SUBMITTAL OF HANFORD FACILITY RESOURCE CONSERVATION AND RECOVERY
ACT (RCRA) PERMIT MODIFICATION NOTIFICATION FORM 24590-LAW-PCN-ENV-
07-003

Modification Notification Form 24590-LAW-PCN-ENV-07-003 updates the Low-Activity
Waste (LAW) Vitrification Building Piping and Instrumentation Diagrams for the LAW Primary
Offgas Process System Melter 1 and LAW Primary Offgas Process System Melter 2, in
Appendix 9.2 of the Reference.

Hanford Facility RCRA Permit Modification Notification
Form 24590-LAW-PCN-ENV-07-003

24590-LAW-M6-LCP-P0001

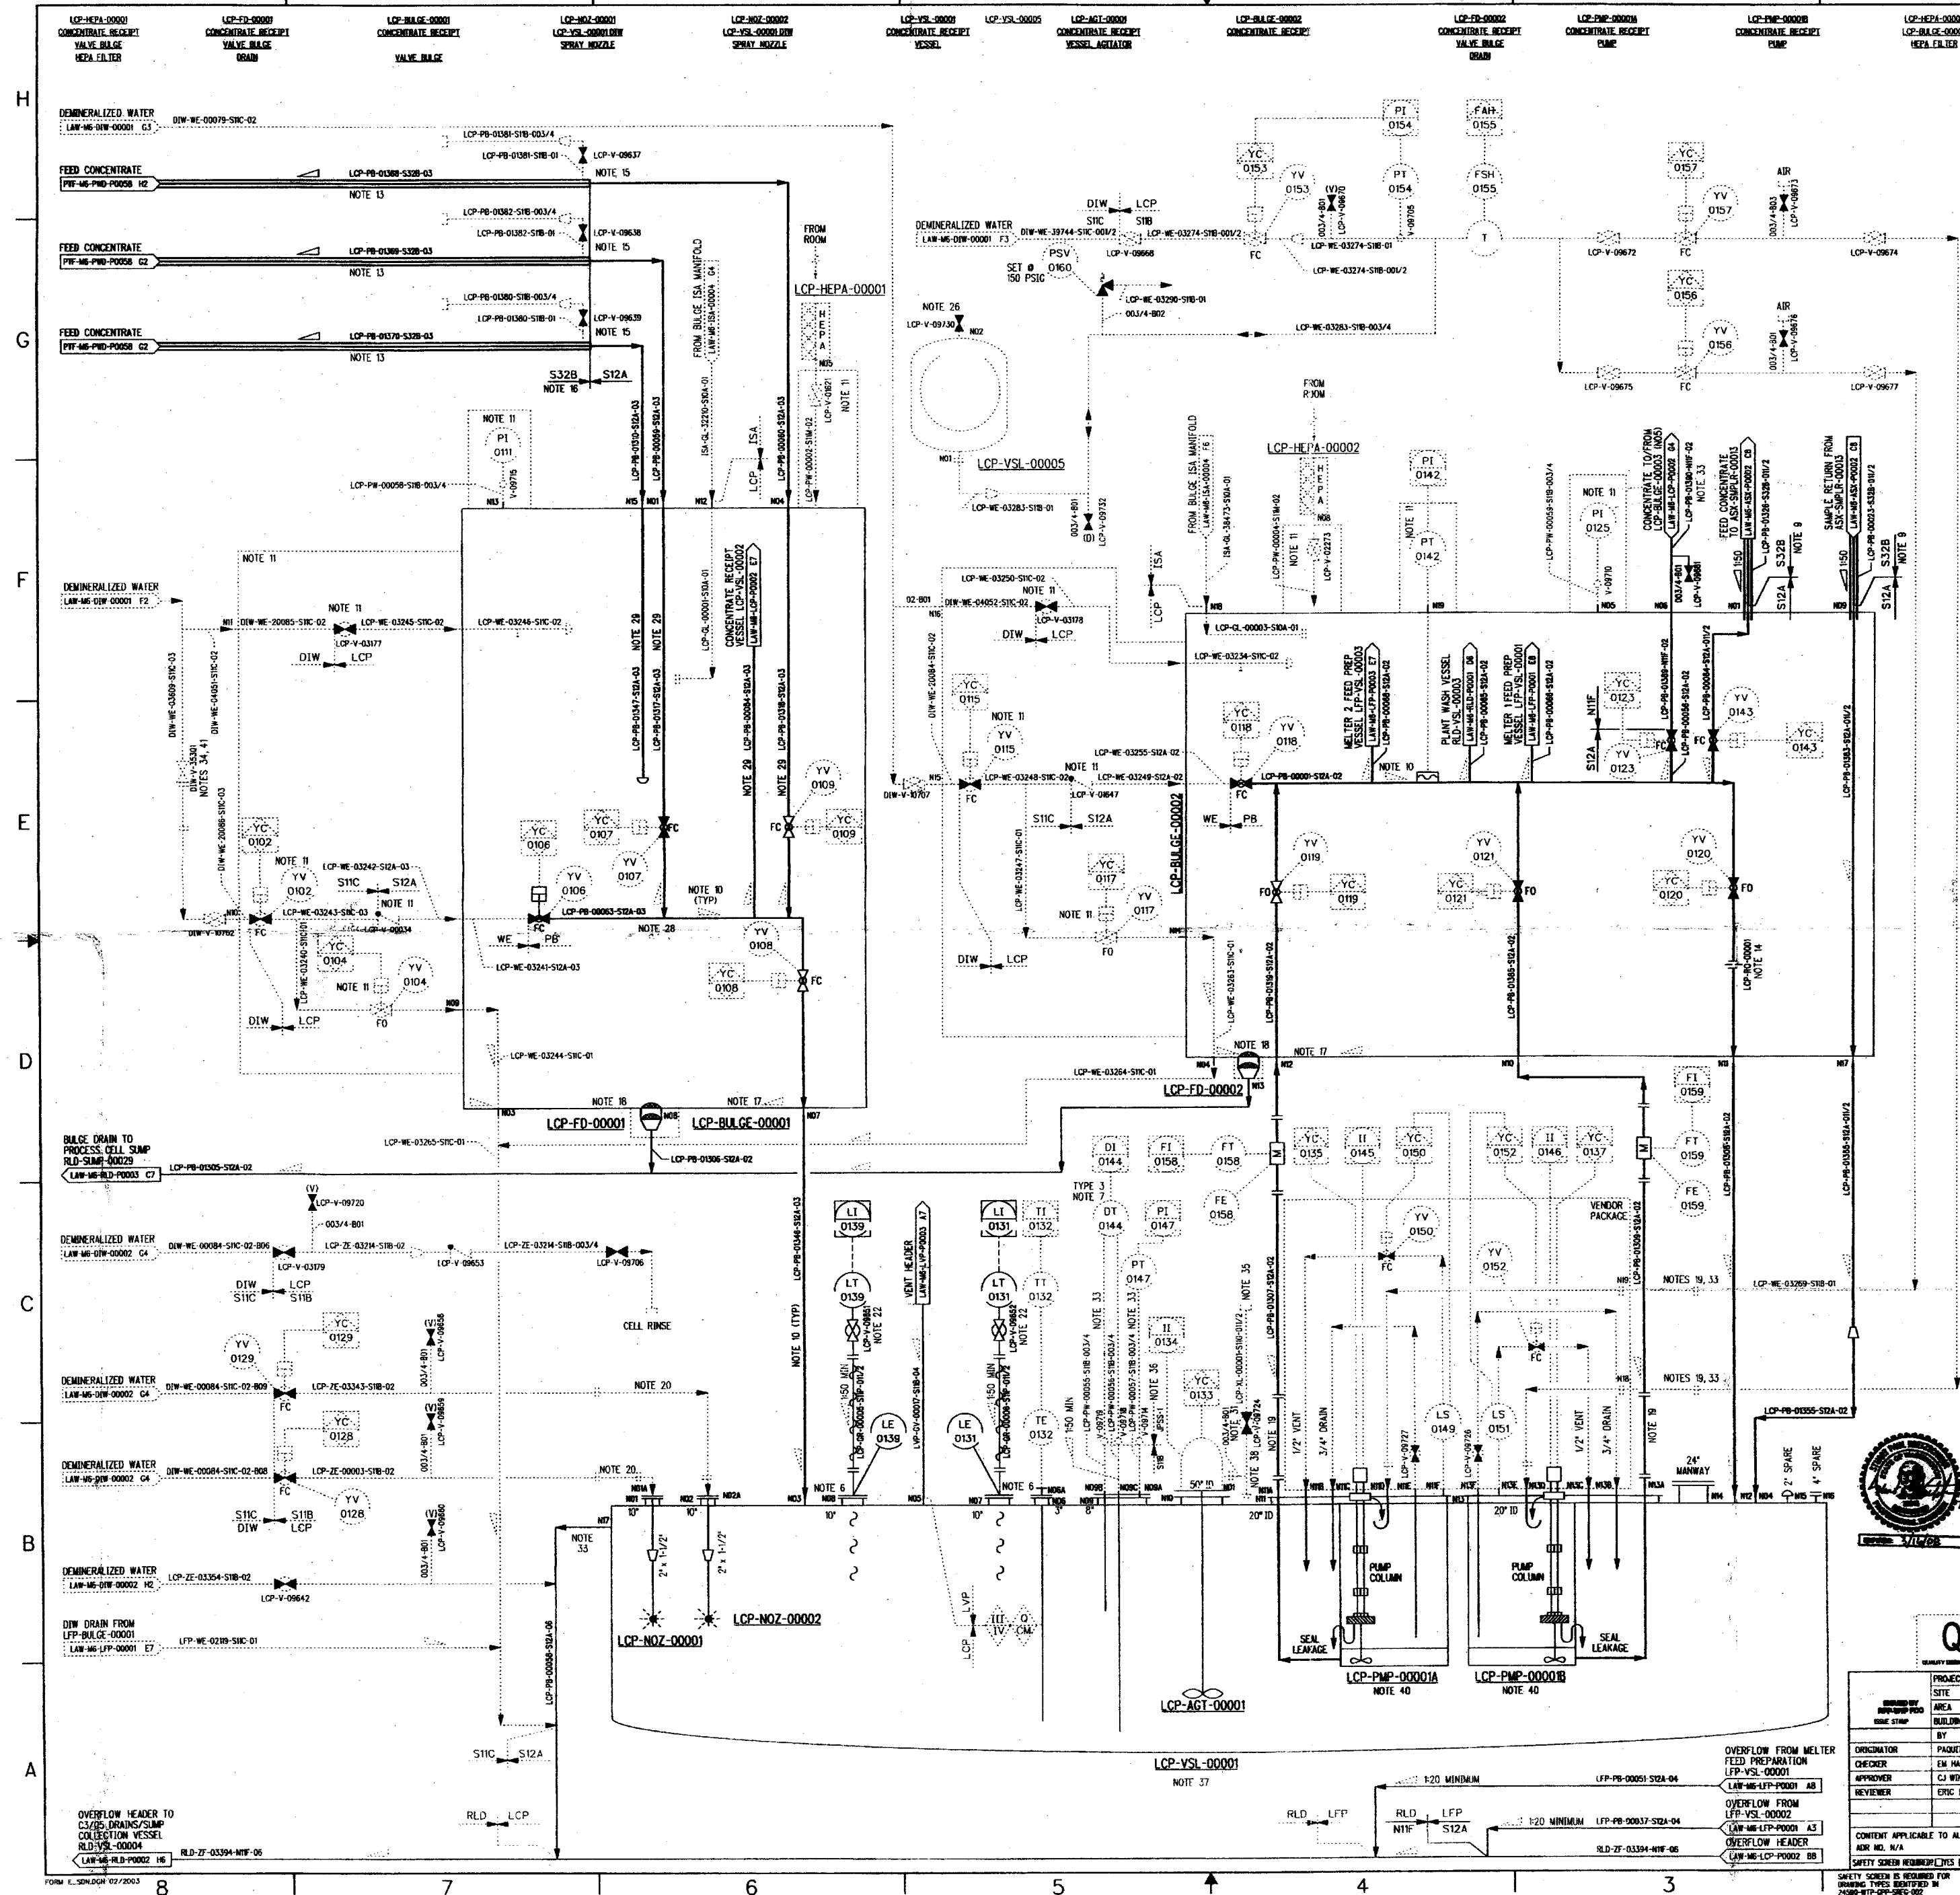
LAW Vitrification Facility - Piping and Instrumentation Diagram P&ID 24590-LAW-M6-LOP-P0001 (Rev. 2)

The DCNs associated with changes to P&ID 24590-LAW-M6-LCP-P0001 are provided in drawing Note 54.

- Added and revised various notes as symbols and legends, slopes, reducers, valve locations, and system designators
- Added slope notation to numerous lines including bulge piping
- Corrected numerous off-sheet coordinates
- Added Seismic Category flags and incorporated various editorial comments
- Added reducers and nozzles to WESP purge heaters
- Deleted pressure control valves and added orifice plates, nozzle numbers, and reducers to LOP-HTR-00001
- Added reducers to show 8" LOP-FV-1140 on 10" line between offgas LVP HTR-00001A/B and LOP-WESP-00001
- Added instrument service air from ISA manifold to bulge LOP-BULGE-00001
- Incorporated various editorial comments

LAW Vitrification Facility - Piping and Instrumentation Diagram P&ID 24590-LAW-M6-LOP-P0002 (Rev. 2)

The DCNs associated with changes to P&ID 24590-LAW-M6-LCP-P0002 are provided in drawing Note 53.

- Added and revised various notes as symbols and legends, slopes, reducers, valve locations, and system designators
- Added slope notation to numerous lines including bulge piping
- Corrected numerous off-sheet coordinates
- Added Seismic Category flags and incorporated various editorial comments
- Added reducers and nozzles to WESP purge heaters
- Deleted pressure control valves and added orifice plates to LOP-HTR-00002
- Added reducers to show 8" LOP-FV-2140 on 10" line between offgas LVP HTR-00001A/B and LOP-

- Added instrument service air from ISA manifold to bulge LOP-BULGE-00002
- Incorporated various editorial comments
